Access Compliance Report

Public Rights-of-Way

Intersection ID: 27900	Main Street: FROHOCK_PL	Cross Street: HARRISON'S_CROSSING_AV	Location: S
ADA ID: 1E887C8D9853	Ramp Type: BlendTrans2	Initial Pass/Fail: Fail	Overall Compliance: No
Severity Score: 25			
Codes/Mitigation Info/Possible Solution		Field Measurements/Component Compliance

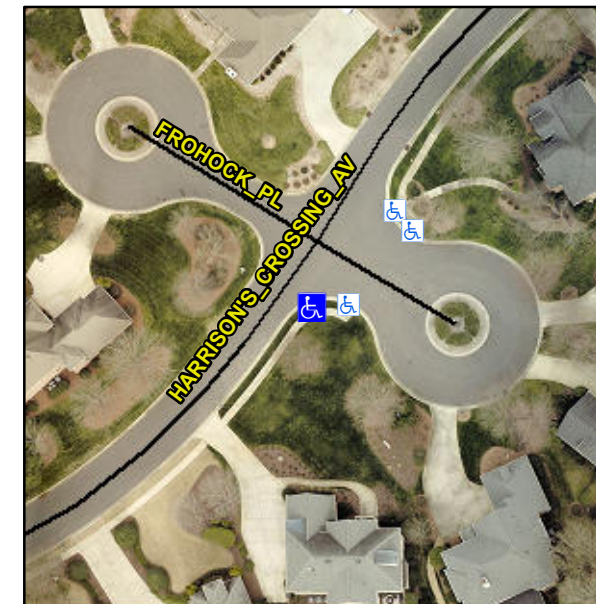
Not Found, R304.5.3

Compliance	Description	Data	Compliance	Description	Data
N/A	Ramp Length (in)	95.0	Yes	BlendTrans Slope (%)	0.8
Yes	Ramp Width (in)	48.0	No	BlendTrans XSlope (%)	9.7
N/A	Flare Type LT	N/A	N/A	Flare Type RT	N/A
N/A	Flare Slope LT (%)	N/A	N/A	Flare Slope RT (%)	N/A
N/A	Flare Traversable LT?	N/A	N/A	Flare Traversable RT?	N/A
N/A	Landing Length (in)	N/A	N/A	DWS Provided?	N/A
N/A	Landing Width (in)	N/A	N/A	DWS Contrast?	N/A
N/A	Landing Slope (%)	N/A	N/A	DWS Length (in)	N/A
N/A	Landing X Slope (%)	N/A	N/A	DWS Full Width?	N/A
N/A	Landing Curb? (Y/N)	N/A	N/A	DWS Offset (in)	N/A
N/A	Shared Landing?	N/A			
N/A	Gutter Ponding?	N/A	N/A	Gutter Slope (%)	N/A
N/A	Gutter Lip Ht (in)	N/A	N/A	Gutter X Slope (%)	N/A
N/A	Painted X Walk1?	No	N/A	Painted X Walk2?	N/A
	X Walk 1 Direction	To NW		X Walk 2 Direction	N/A
	X Walk 1 Width (in)	N/A		X Walk 2 Width (in)	N/A
	X Walk 1 Slope (%)	0.7		X Walk 2 Slope (%)	N/A
	X Walk 1 X Slope (%)	8.7		X Walk 2 X Slope (%)	N/A

N/A	Ramp inside XWalk1?	N/A	N/A	Ramp inside XWalk2?	N/A
	Road Slope (%)	8.7		Clear Space?	N/A
	Road X Slope (%)	0.7	N/A	Clear Space to XWalk (in)	N/A
N/A	Any Obstructions?	N/A	N/A	Storm Grate/Utility Hazard?	N/A
	Obstruction Type			Storm Grate/Utility Type	
		N/A			N/A
			Yes	Surface Condition? (G/P)	Good
			No	Curb Slope (%)	9.8

Remove & Replace Curb Ramp With Two New Directional Ramps or Equivalent.
